HISTORIC LANDMARKS COMMISSION

OCTOBER 10, 2013

Subject: **REQUEST FOR A CERTIFICATE OF APPROPRIATENESS, HC2013-21**, submitted by Leslie C. Ferguson, agent, on behalf of Saint John's Episcopal Church, applicant and property owner, for the replacement of a wooden shake roof with an engineered synthetic shake on a religious structure located at 828 Kings Highway. The parcel is further identified as Zoning Map 10 Parcels 48A and 49, Chuckatuck Voting Borough, zoned A, Agricultural District, and HC, Historic Conservation Overlay District.

Subject: **Request for Certificate of Appropriateness HC-2013-22**, submitted by James E. Butler, III, President, Riddick's Folly, applicant and agent, in partnership with the City of Suffolk, property owner, for exterior renovations of an existing structure located at 510 N. Main Street. The property is further identified as Zoning Map 34G11 Block (A) Parcel(s) 142, Suffolk Voting Borough, and is zoned CBD (Central Business District), and HC (Historic Conservation Overlay District).

Southwest View of the Law Office

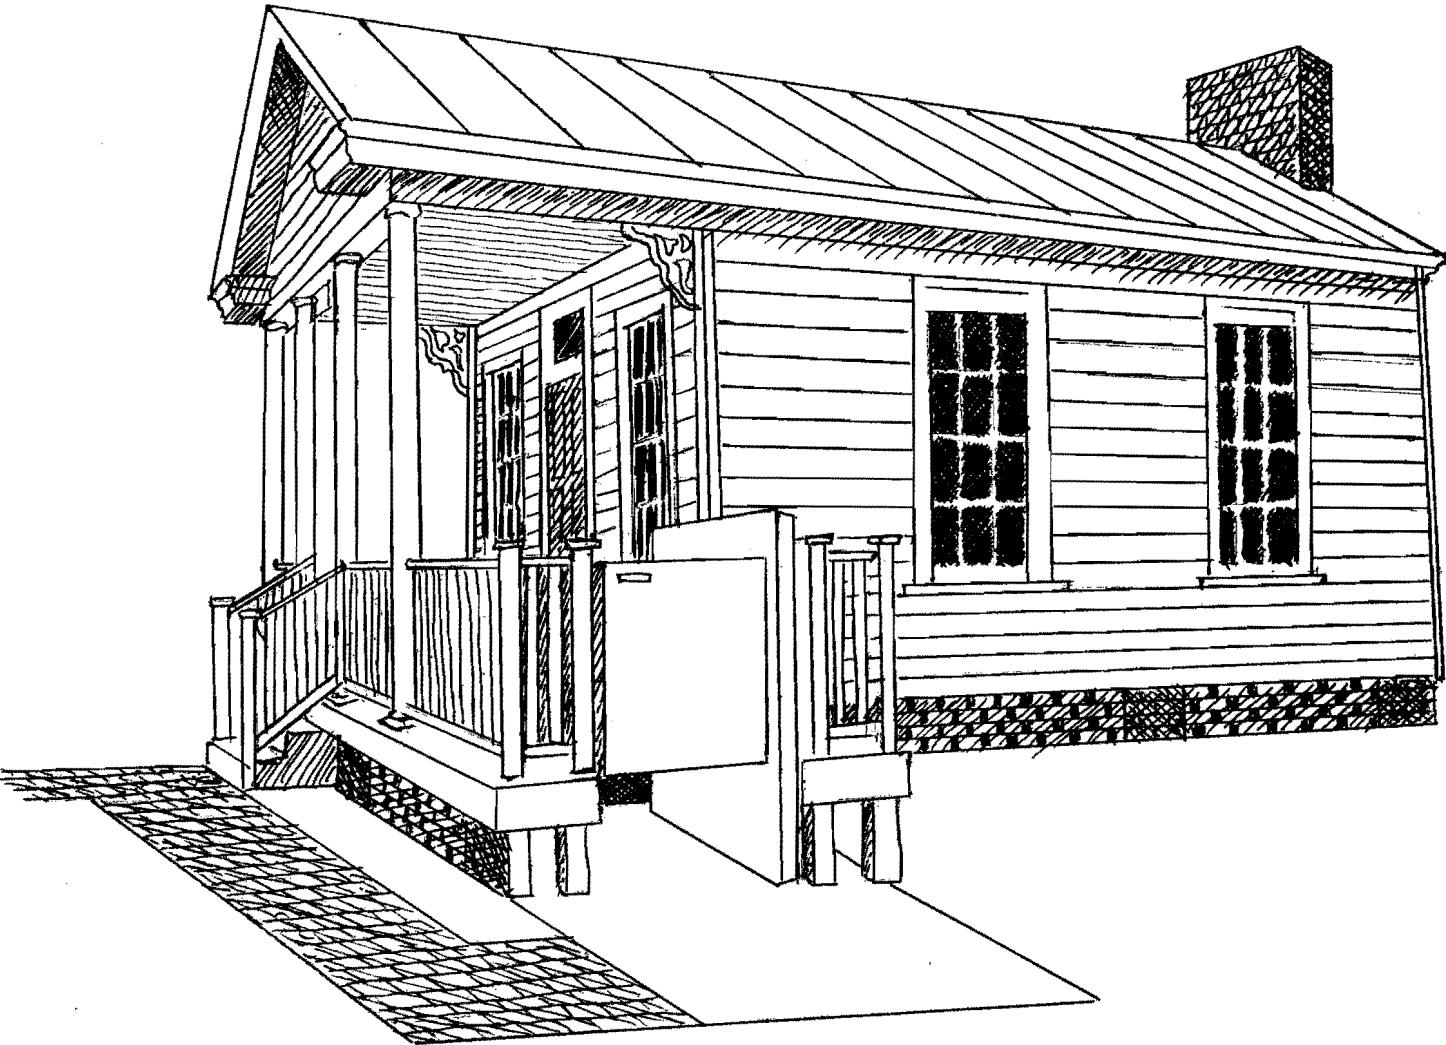
We would like to remove the four existing pine columns on the front porch of the law office. Their replacement would be DuraCast Fiber-glass columns. We would also like to replace the existing cypress flooring with four inch salt treated tongue in grooved floor boards and restore the handrail where needed. We will clean, scrape, spot prime and paint with two finish coats of Benjamin Moore exterior paint on all exterior surfaces of the building. All colors that were approved in 2004 will remain the same.

1. The existing porch decking may be rehabilitated using pine tongue and groove decking and “Dura cast” fiberglass columns. Minor repairs to handrails using like-kind materials may be performed. All materials shall be the same proportion, dimension and profile as original. All materials shall be painted to match existing.
2. The existing handicap ramp may be removed and a lift to provide access may be installed on the southwest corner of the existing porch. Landscaping shall be retained to screen the ramp.
3. No further exterior improvements permitted without the issuance of a Certificate of Appropriateness.
4. All required permits shall be obtained from the Community Development Division upon approval of a site plan from the Planning Division.

Southwest View of the Law Office

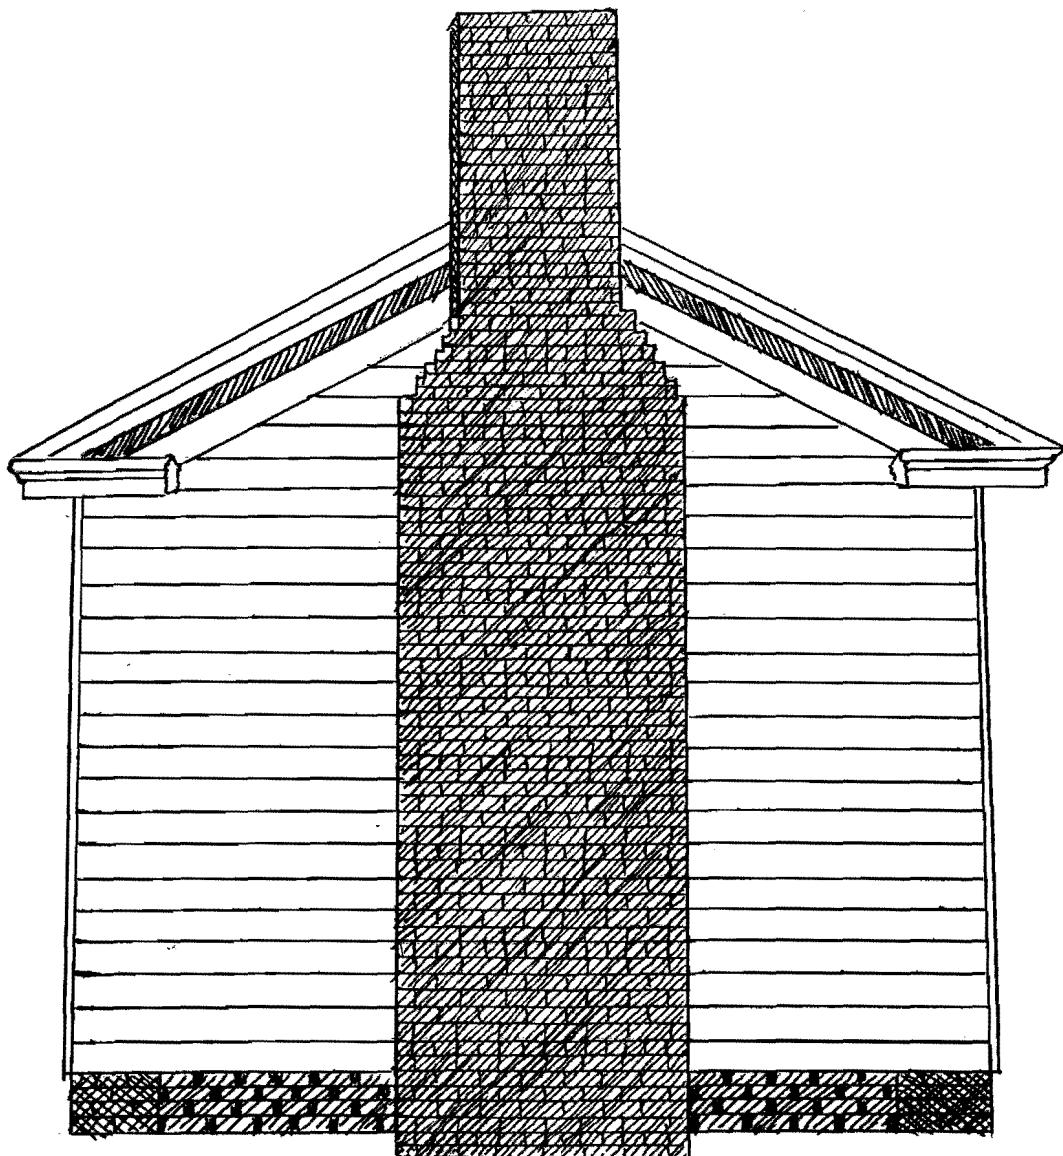
We would like to remove the existing handicap ramp that you will see in the color photographs. Its replacement would be a mechanical lift that would be inserted in the south end of the front porch. A brick walk would connect to the existing front brick walk of the law office and extend to the base of the mechanical lift where it would connect to a six foot by six foot concrete pad in front of the mechanical lift.

Commercial Wheelchair lifts

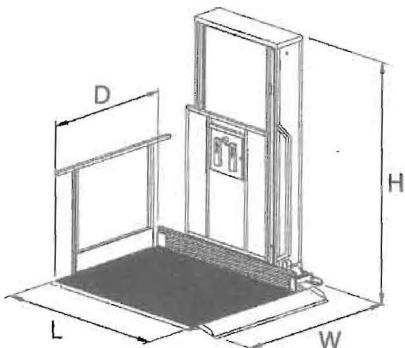
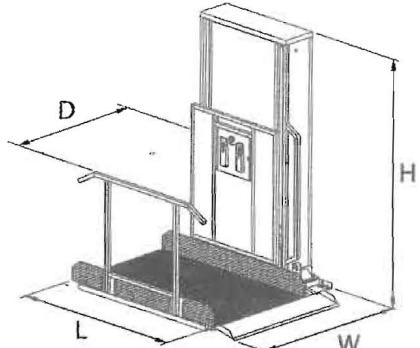
We would like to remove the handicap ramp from the rear and south side of the building because of the continuing maintenance that it requires and replace it with a mechanical lift on the south end of the front porch. A brick sidewalk would be installed from the existing front walk of the law office, run south and connect to a six foot square concrete pad in front of the mechanical lift.
